Reference: **COLES LINDFIELD**

ACCESS REPORT- DEVELOPMENT APPLICATION

MIX USE DEVELOPMENT- COLES LINDFIELD 376-390 PACIFIC HIGHWAY, 1 BALFOUR STREET & BALFOUR LANE, LINDFIELD NSW 2070

Report Number: IAR-0113

Travelator lobby Lower Ground 2

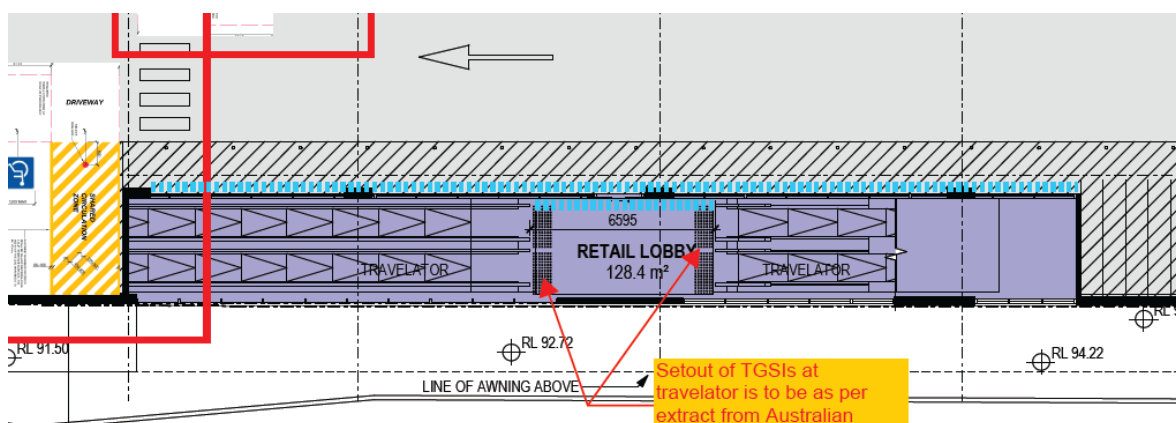
The following extracts from the plans indicate the locations where visual indicators will need to be applied to full height glazing. In addition to these locations the lobby doors provided within the residential component of the development will need to be reviewed.

3.3.1. Visual Indicators The detailed construction documentation yet to be prepared for this project will need to be provided, detailing the application of visual Indicators where full-height glazing is proposed to any glazed wall or door associated with the accessible path of travel within this development.

Extract from Lower Ground Floor 2 Plan

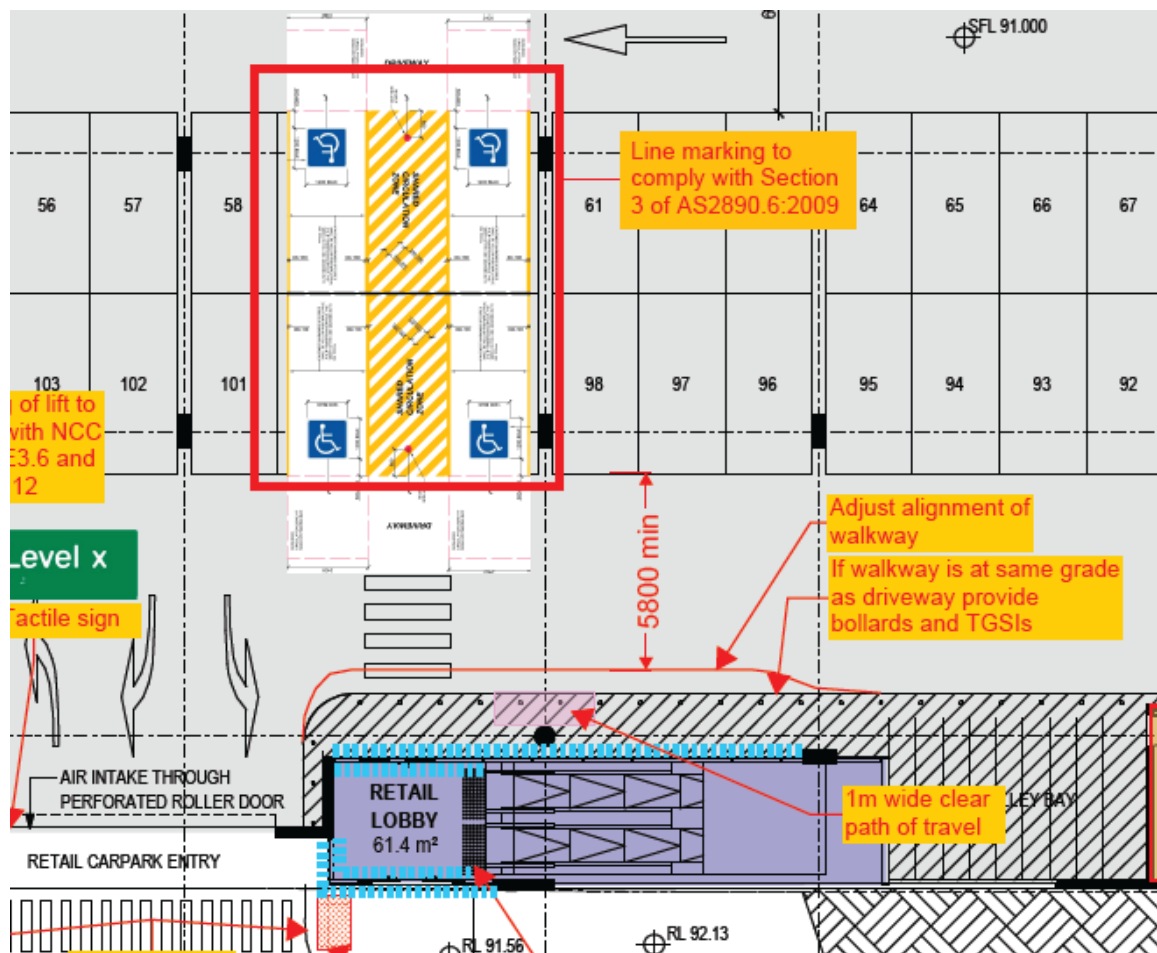
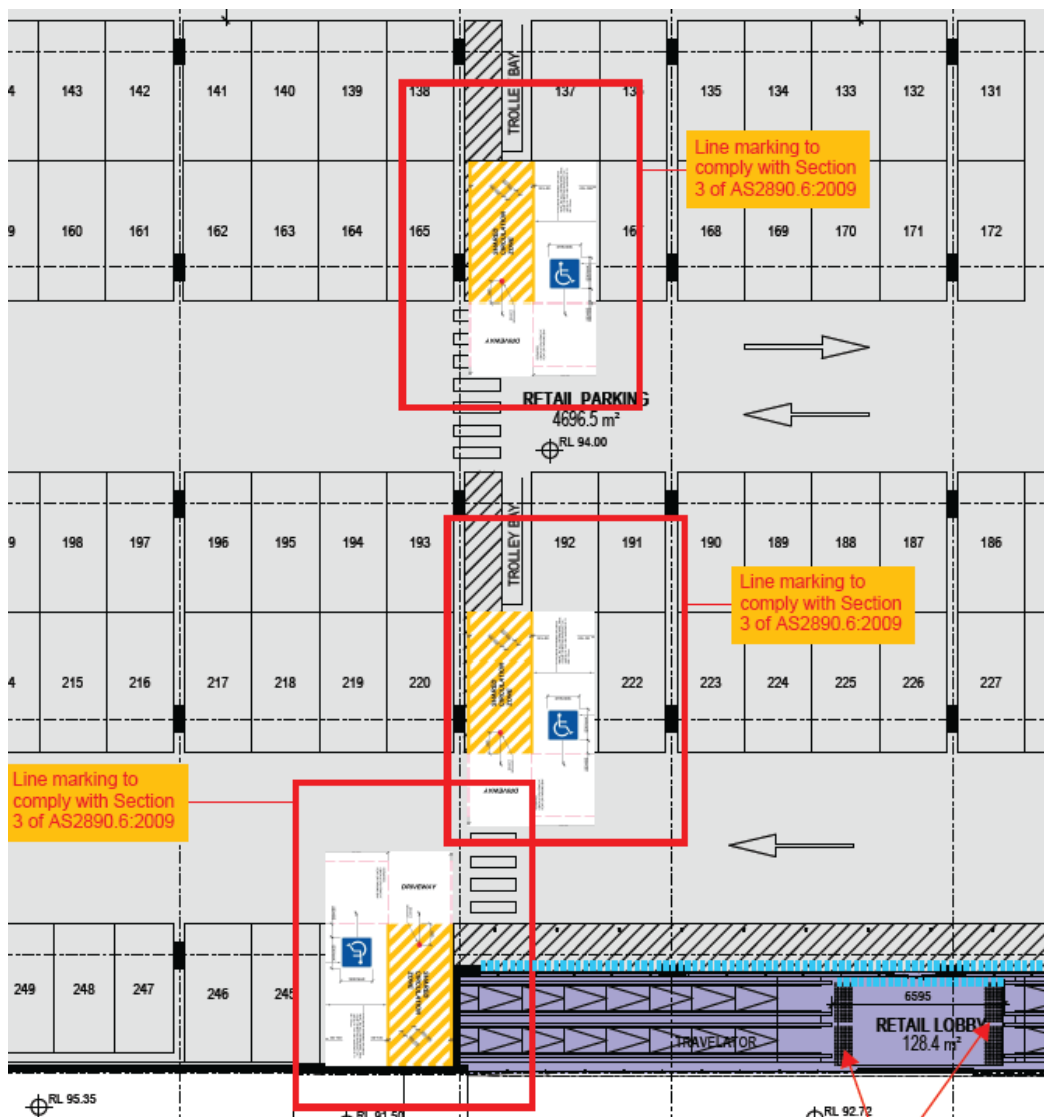
Accessible parking spaces in accordance with the provisions of NCC Table D3.5 have been provided. The sizing and detailing of the retail accessible parking spaces is in accordance with AS2890.6:2009.

Compliance: Accessible carparking is capable of achieving compliance.
